**BLM SCALAR FIX** -Based on findbhudda's original design:  
<http://www.midibox.org/dokuwiki/doku.php?id=findbuddha>

Corrected blm-scalar v1.1.brd [blm-scalar\\_v1.1.brd.zip](#)

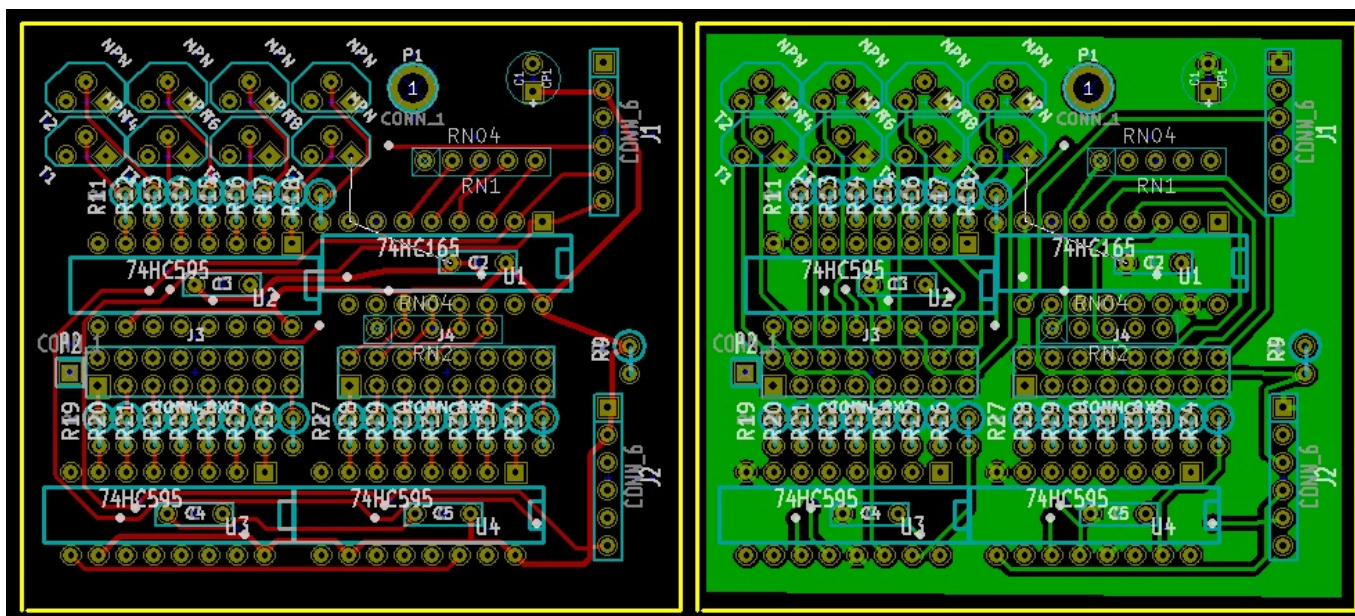
- blm-scalar.\* contain an error. Pins I4-I7 are mirrored. This is easily fixed with a connector modification, and the blm-scalar module seems to work as intended.
- blm-scalar v1.1 attempts to fix this error. Moved connectors J1, J2, Resistor Net 1 and R9 to make room for corrections.
